Service Letter No. 74

SUBJECT: Attach bolts for spring gear and tri-gear models

AIRPLANES AFFECTED: MXT-7-180, S/N 14000C-14137C, M-8-235, S/N 15001C-15005C, MXT-7-160, S/N 17001C-17008C, MT-7-235, S/N 18001C-18109C, MXT-7-180A, S/N 21001C-21097C, M-7-235C, S/N 25001C-25117C, MT-7-260, S/N 27001C-27015C, MX-7-180C, S/N 28001C-28028C, M-7-420AC, S/N 29001C-29007C, M-7-260C, S/N 30001C-30060C, MX-7-180AC, S/N 33001C-33010C, MX-7-160C, S/N 34001C, MT-7-420 S/ N 51001C, 51002C

Detail -1

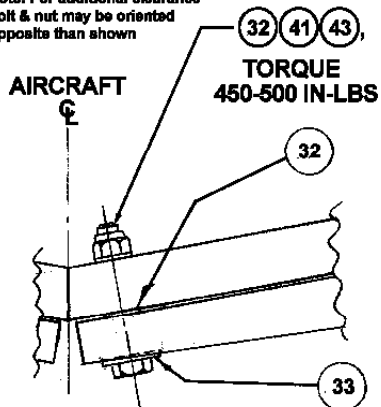
1) Install the following per **Detail -1:**

Note: Apply LPS 3 (Rust inhibitor, Heavy Duty) liberally during assembly of inboard bolt attachment – to bolt holes and washer surfaces – to bolts, nuts and washers – also applies to outboard attachment and axle assembly attachment.

Detail -2

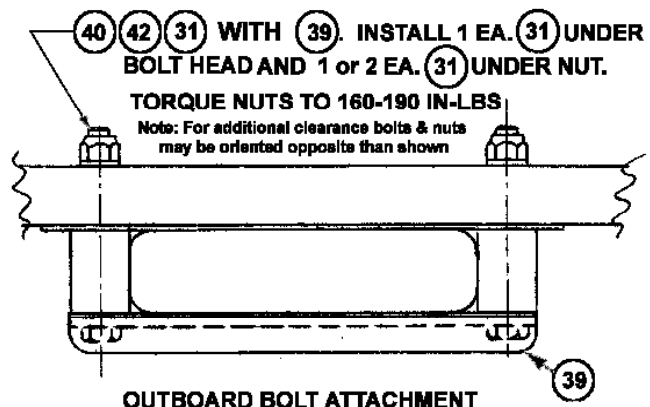
2) Install the following per **Detail -2:**

Note: The maximum combined height of washers that should be used is 1/8 inch and should have at least one thread of the bolt protruding through the nut.

Note: For additional clearance bolt & nut may be oriented opposite than shown
